LOCKHEED AIRCRAFT CORP.		ENGINEERING STUDY <input type="checkbox"/>		CHANGE PROPOSAL <input checked="" type="checkbox"/>		LAC -93-1*				
DATE 6-6-61		AFFECTS : WSPO <input checked="" type="checkbox"/>		PROJECT <input type="checkbox"/>						
NAME OF MAJOR COMPONENT		PART OR LOWEST SUBASSEMBLY		PART NO. & MODEL OR TYPE						
TITLE OF PROPOSAL : OXYGEN SYSTEM IMPROVEMENTS										
NATURE OF PROPOSAL :  SEE PAGE 2   *(Revised to include aircraft 388/721 and 394/954 - see Item 4.)										
REASON FOR PROPOSAL : To incorporate supplemental safety provisions in the ships oxygen system to reduce fire hazard without detriment to existing efficiency. Proposed improvement include: 1. Use of slow opening manual control valves in place of present automatic opening connectors and the on-off feature of the pressure reducers to eliminate high pressure surges and resulting adiabatic heating. 2. Removing the cockpit low pressure gage to prevent possible misinterpretation of indicated pressures. 3. Relocating the modified pressure reducers and (improved) relief valves from the cockpit to the Q-bay within a box for protection against grease and dirt. Except for the high pressure gage, only low press

FIGURE 2.

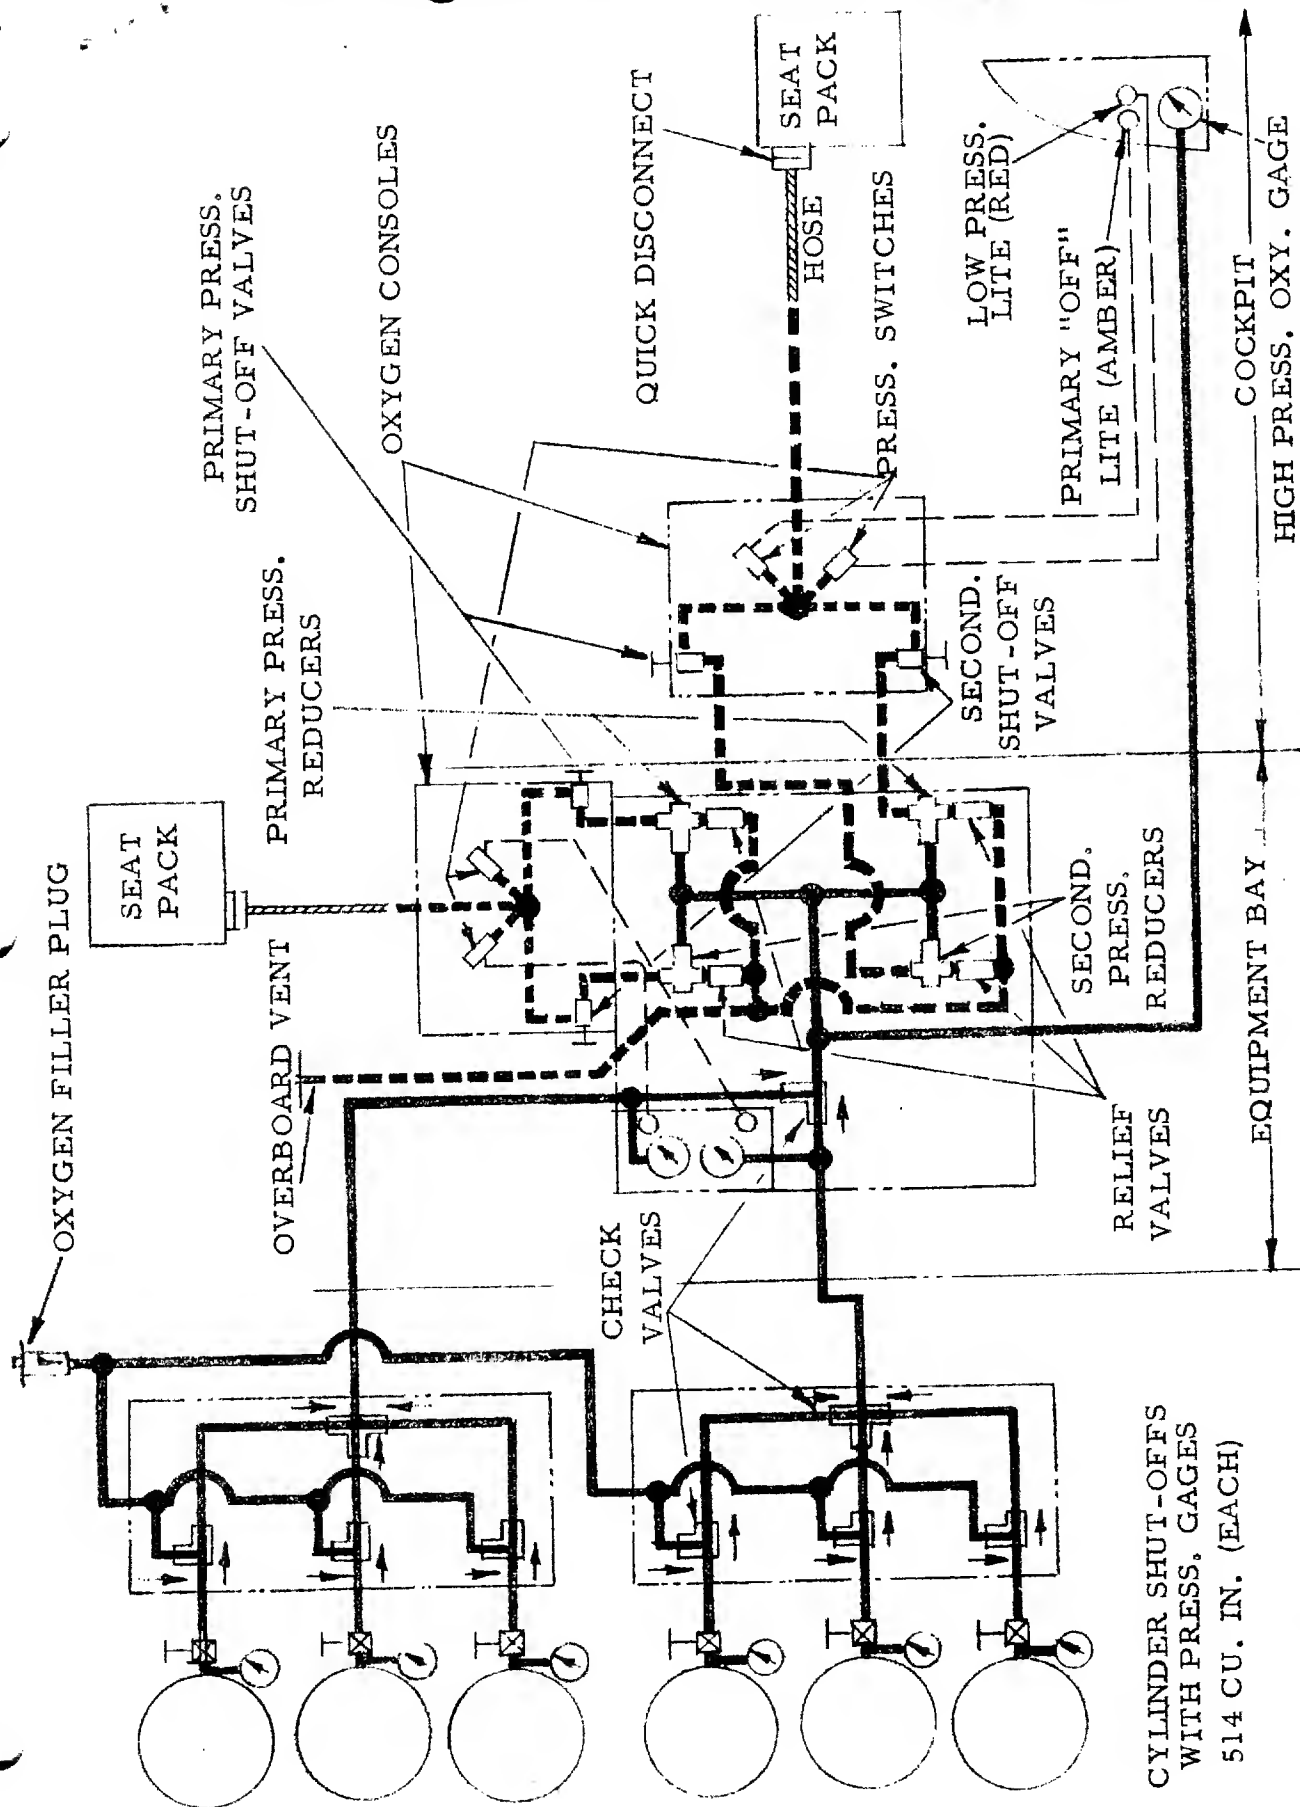
2. Prepare and issue a Service Bulletin.
3. Fabricate appropriate aircraft provisioning kits.
- \*4. Modify aircraft 388/721 and 394/954 as follows:
  - a. Cockpit - Same as Item 1.a. except see Figure 2.
  - b. Q-Bay - Install improved relief valve and rework pressure reducers for both pilot and equipment operator in existing equipment operators left-hand side console.
